HURRICANE CITY UTAH

Hurricane Planning Commission Meeting Agenda

January 26, 2022

**40 TOTAL ACRES
Approx 2.5 LOTS/ACRE**

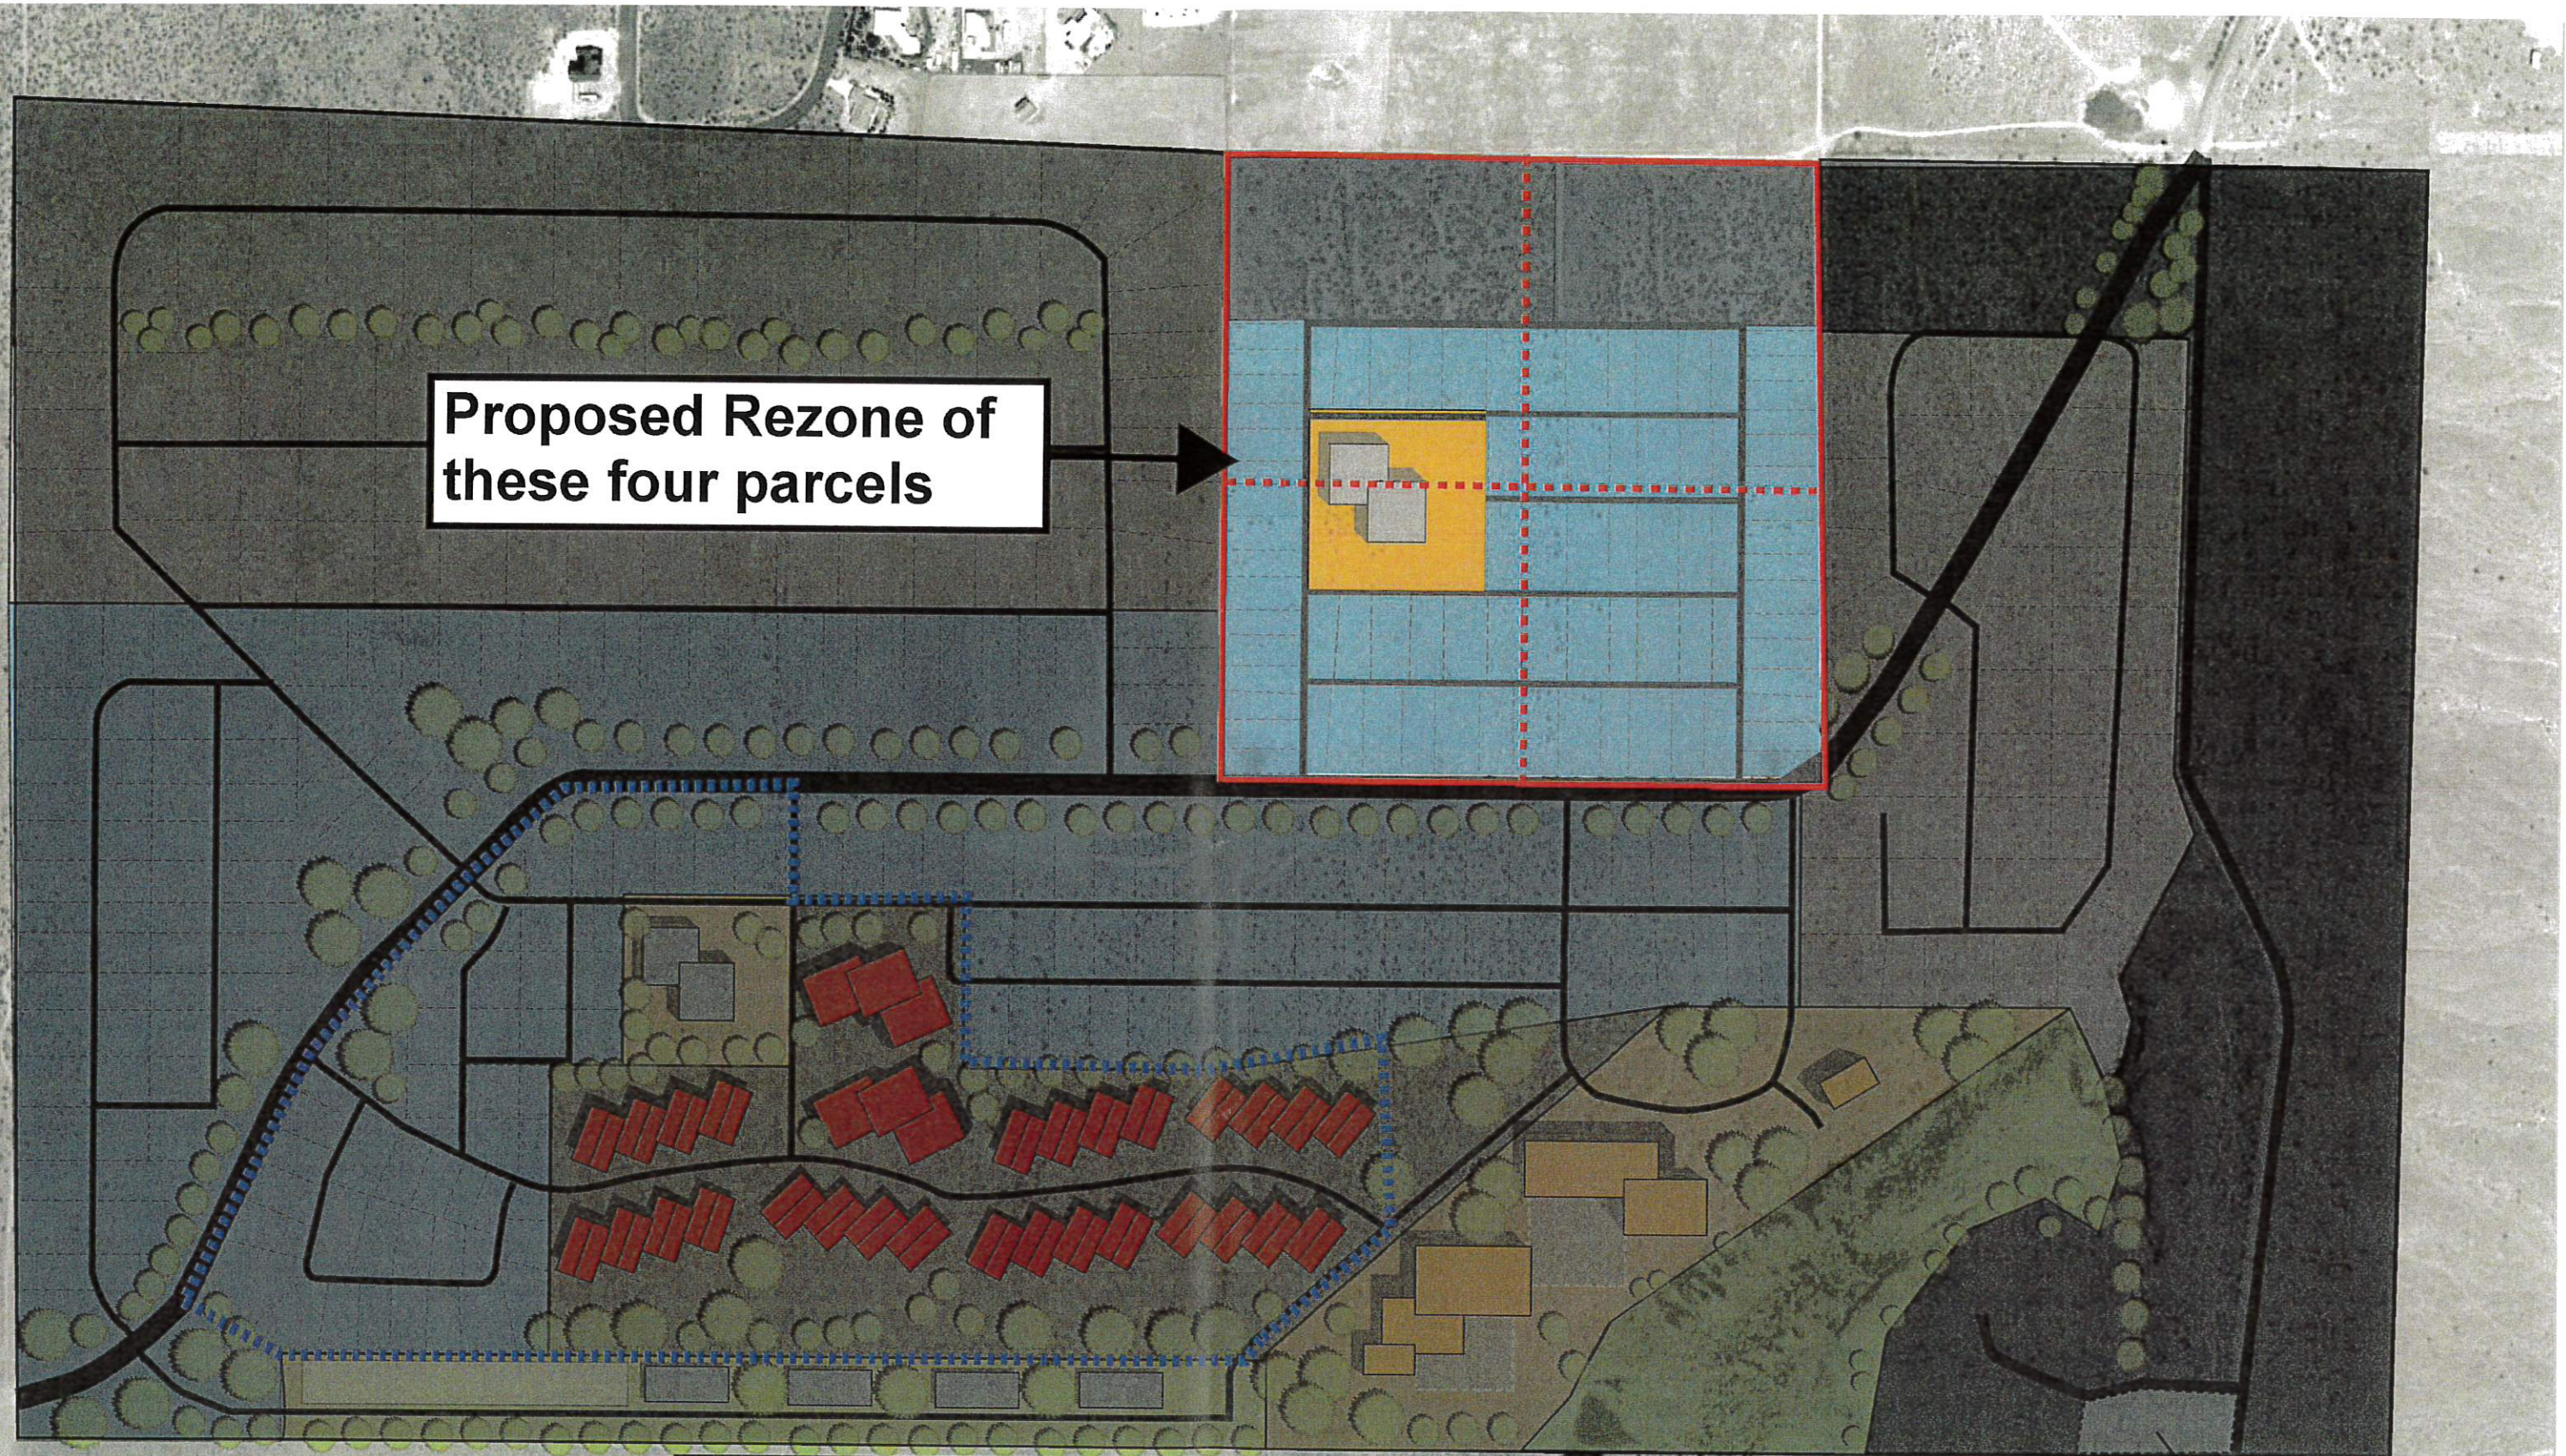
2. **Density:** The site plan provided says 40 acres at 2.5 units an acre for a total of 100 new units. The site plan appears to show 86. The site plan shows the majority of the area in question will be quarter-acre lots with one-acre lots on the northern section.

- a. Their applicant has conflicting densities listed. One section of the application states that the application is seeking 2.5 units an acre, but another sheet states that they are asking for 3.5 units an acre. This needs to be corrected to ensure there is no conflicting information.

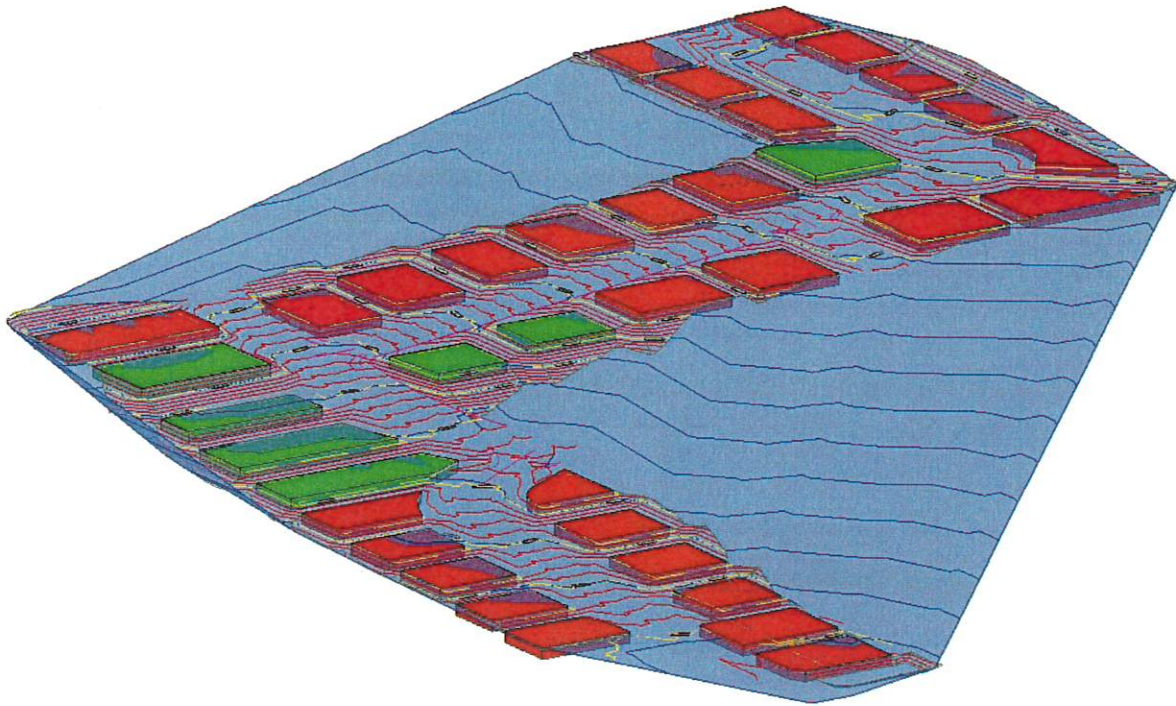
1. Update: The applicant is wishing to create five additional lots by splitting the lots shown above in green. The initial application was approved on Nov 29, 2021 by the City Council. The new lots are 28-32 and 7-10. As will be mention below, these lots do not comply with the sensitive lands table minimum lot size for the slop. Staff has talked to the applicant's engineer and requested a letter to address the above exception. See [HCC 10-24-6. - Hillsides and ridge areas; general development standards.](#)
2. The Sensitive Land Application is complete. The applicant has provided an updated sloping map and has shown the slope of each lot . The applicant also provided a geotechnical report, drainage Plan, and grading plan with the previous application.

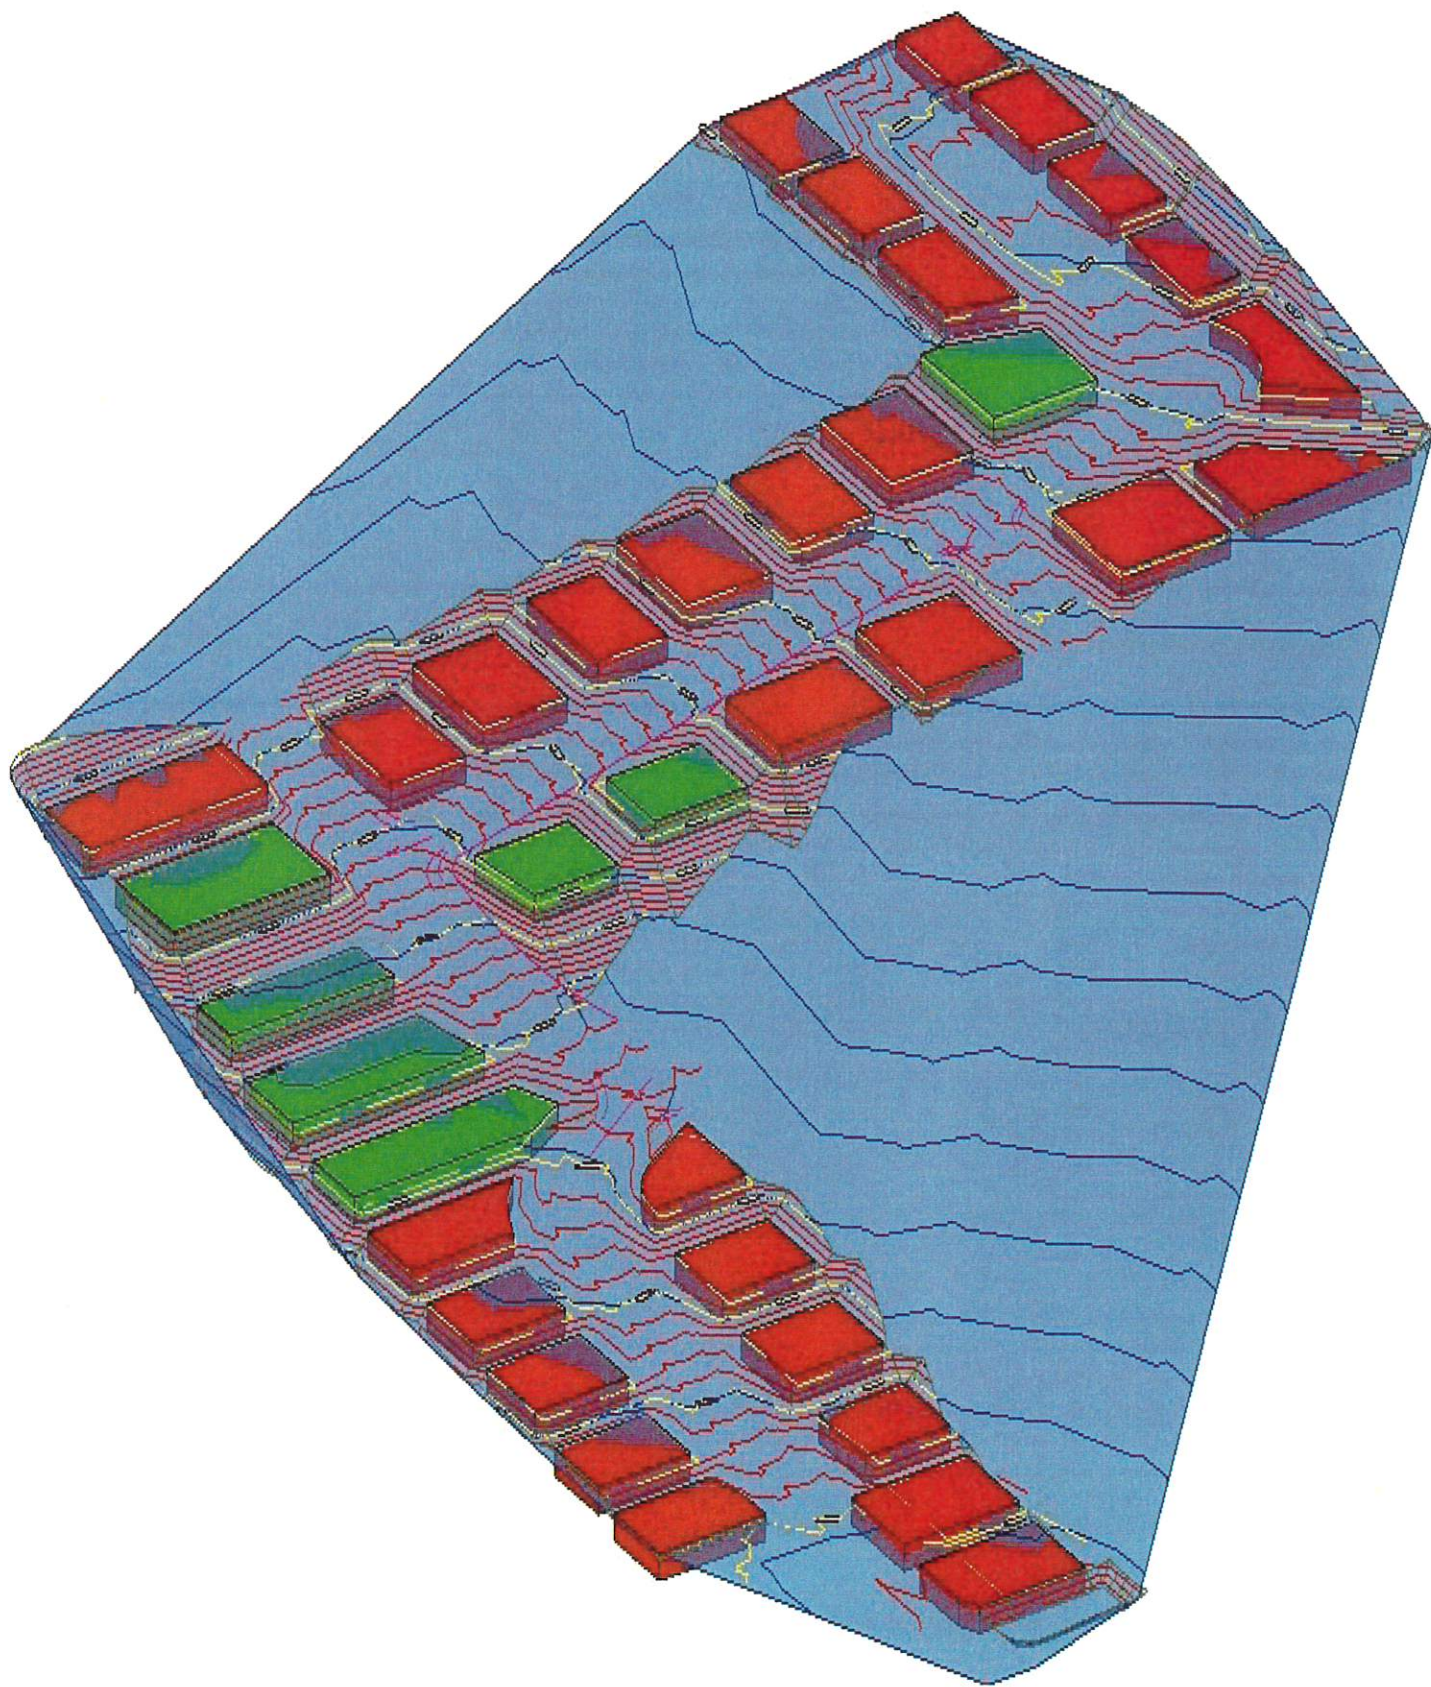
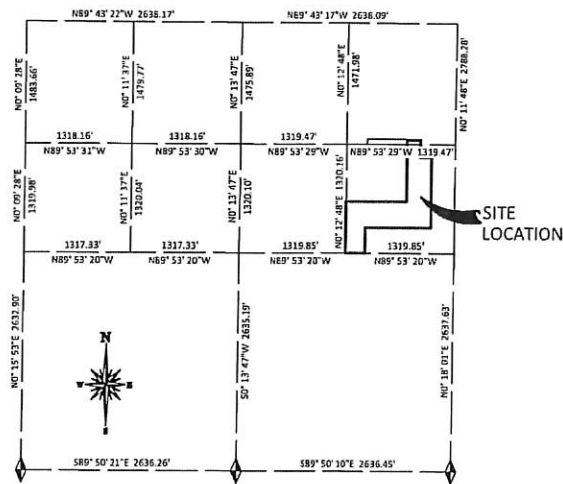
4. The applicant has submitted a grading plan. Grading Plan generally complies with Hurricane Standards with the following notes:
- Slops maximums need to be 2:1. Lot 7 east side and Lot 12 southwest side does not seem to comply.
 - Any walls must be under 16 ft within a run of 50' area.
 - No walls should be placed in PUE. None are shown on the preliminary grading plan.
 - The full grading plan will be reviewed with construction drawings by JUC.
 - Grading Plan Notes 1 appears to be incomplete.
